## BGA TECHNICAL COMMITTEE

### TECHNICAL NEWSHEET 3/4/96

Airworthiness Directive

K 8  
Technical Note  
No. 24

Fig. A2

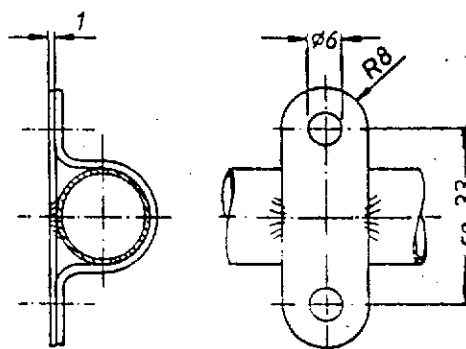
- ad A2) Checking the rudder pedals:  
With the rudder neutral the pedals left and right must be evenly adjusted. Check the pedal board angle versus the pedal dimensions (see drawing L-216.42-U01). The angle must meet the specified dimension.  
Engage the pedal adjustment into its foremost position and check full deflection of the rudder.  
Where pedals or attachment collars are bent, these can be either repaired or replaced by new ones.  
In order to impede the bending of the pedal boards it is optionally recommended to weld an additional butt strap onto the attachment collar (see Fig.A2).

Reinforcing the attachment collars for pedal boards at the pedal assembly. Material: 1.7734.4  
Welding procedure WIG to spec DIN 1912, welding wire material: 1.7734.2

Subject : Glass fiber laminate covering the spar stub fittings

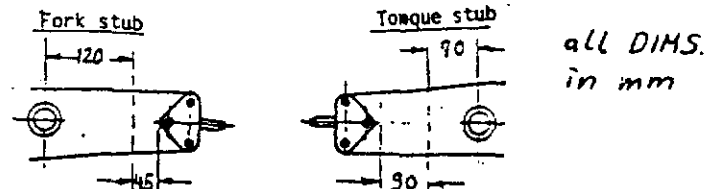
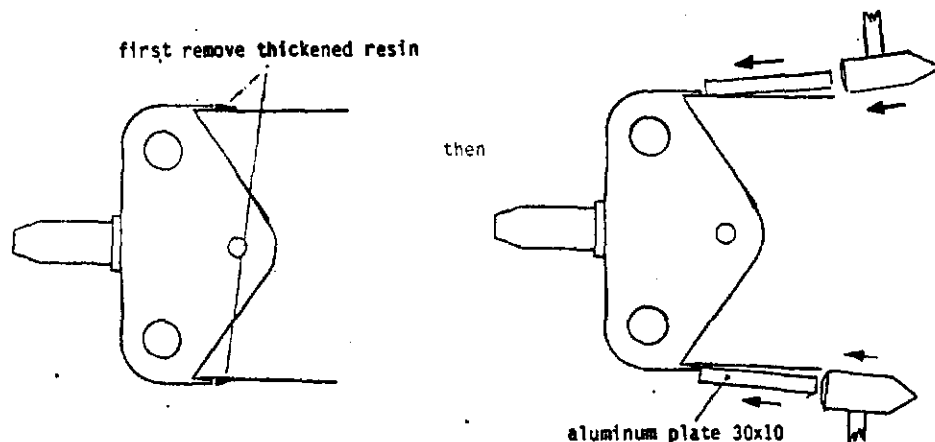
Reason : Separation of laminate from wing attachment fittings allowing the ingress of moisture which in turn may lead to corrosion

Actions : 1. Inspection for a separation of the laminate at each annual inspection.  
A separation of the laminate is recognized by gaps showing at the face of the spar stub(s).  
If gaps are found, the fitting must be checked for corrosion by carefully lifting the laminate.  
If the fitting is free from corrosion, the laminate must be rebanded to the fitting as follows:  
Place wing leading edge down on trestles. Using thin wooden wedges force the gap to open and, with the aid of a syringe (internal diameter of needle to be 0.8 mm), carefully inject thickened resin into the cavity (Scheufler resin No. 285, mixed 100 : 38 with hardener No. 285 and "Aerosil" added).  
Next remove wedges and, using two clamps, two 8 mm hard core foam plates and two 16 mm wooden boards, press laminate against fitting and remove excessive resin. After curing and heat treatment (for 12 hours at 54° C) sand spar stub face and apply UP gelcoat (Schwabbellack).

First remove gelcoat from spar stub (if such was applied by the manufacturer) and remove laminate as shown in the sketch (such preparing the area to be scarfed later on) -

Drive out hollow rivets imbedded in the spar flanges - but make sure that a counter weight is held against the driving force, Thereafter, with rivets removed, carefully loosen and extract the fitting with the aid of an aluminum plate - see sketch.

Next sandblast the fitting (Using only approved material) and apply a fresh corrosion protection. Then carefully smooth the spar stub (using a 400 grid sand paper), apply a thin coat of resin, push fitting fully home and install hollow rivets. The step between fitting and stub and between connecting glass layers should be filled up using thickened resin.

Finally the spar stub glass layers must be re-wrapped (note displacement of 15 mm) as shown in the sketch on page 1 (using Scheufler Epoxy resin No.285, mixed with hardener No. 285, laminate to be covered by Nylon cloth).

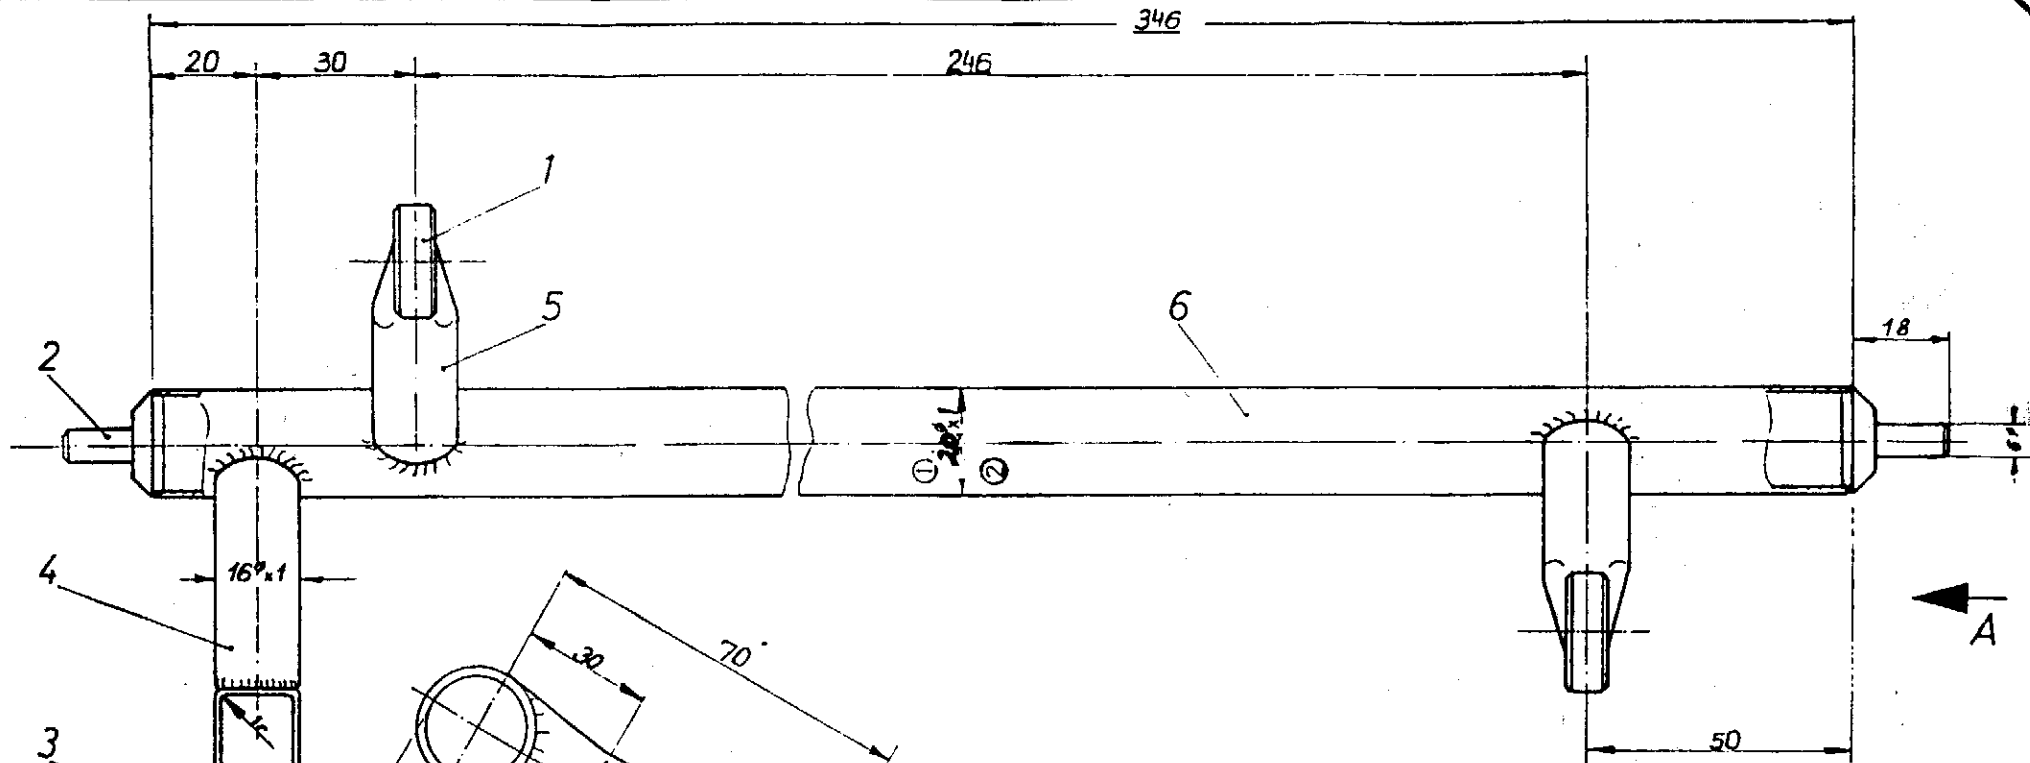
**Reason:** Cracks on aileron operating lever's welding seams due to overloading in case of derigging without disconnection of aileron controls.

**Method 1:** Before the next flight the aileron actuating shaft in the fuselage (see drawing no. 201-47-3 enclosed) must be checked by a licensed inspector nearby the welding seams using an electric torch and a magnifying-mirror (min. double magnification). Overloading of the joint might be indicated e.g. by local paint peeling. If there is any damage in suspect the actuating shaft must be removed and subjected to a magniflux inspection. Magniflux inspection must be done by a licensed aircraft maintenance and engineering service using a inspection procedure proved and permitted for aviation use. If there are no hints on cracks or any other damage flying operation can be continued until 31.12.96. After this date instructions according to either method 2 or method 3 must be accomplished.

**Method 2:** When inspection according to method 1 showed any damage, the actuating shaft must be removed for repair at once ! All welding prescribed below may only be done by a licensed aircraft welder within a licensed and appropriate equipped aircraft maintenance service ! Welding joints must be done with the WIG-inert protective atmosphere welding system (wolfram inert gas welding system) with welding material 1.7734.2 ! First remove all paint. All cracks detected must be welded (groove welding). Then the plates pos. 7 must be welded to the actuating shaft according to drawing no. 201-47-3-1. Finally the actuating shaft must be finished with primer and paint RAL 7003. Reinstallation of the aileron actuating shaft has to be done according to removal.

**Method 3:** If method 2 was not accomplished the original actuating shaft can be replaced by a new and reinforced shaft according to drawing no. 201-47-3, Change "2".

- ① Maß 20x0,75 in 20x1 ab Wnr 508 geändert 20.2.74 Udr.
- ② Dim. 20x0,75 changed into 20x1 after SN 508
- ③ Maß 20x1 in 20x1,5 für Neufertigung ab 2.5.94
- ④ Dim. 20x1 changed into 20x1,5 for reproduction after 2.5.94
